REMARKS

AMENDMENTS TO THE DRAWINGS:

FIG. 1

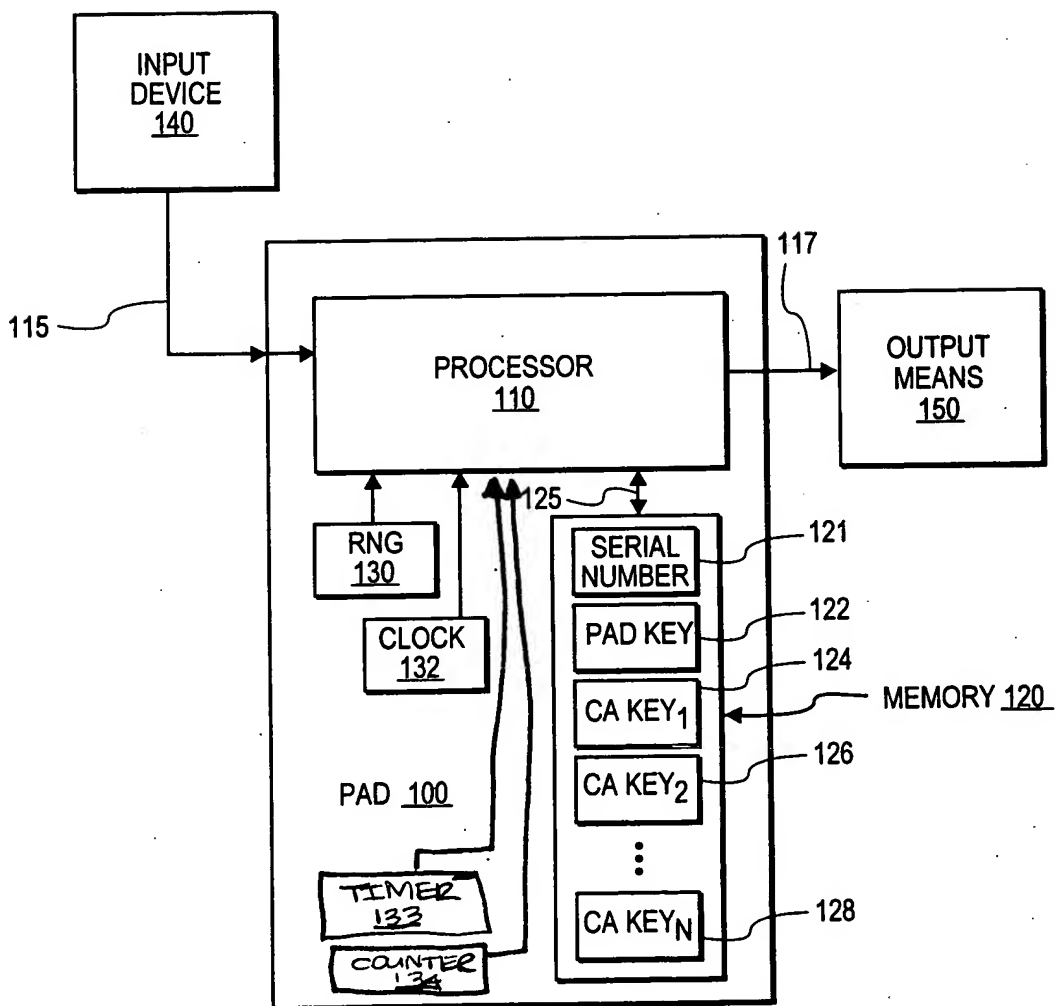
Figure 1 has been amended to add timer 133 and counter 134, which are described in the specification at page 10, line 1, and page 10, line 5, respectively. Because these two items are fully described in the specification, Applicants respectfully submit that no new matter has been added to the application with these changes.

Applicants attach a replacement drawing for Fig. 1, as well as an annotated drawing sheet for Fig. 1 showing the changes. Fig. 1 has been amended to include timer 133 and counter 134, which are described in the specification at page 10, line 1, and page 10, line 5, respectively.
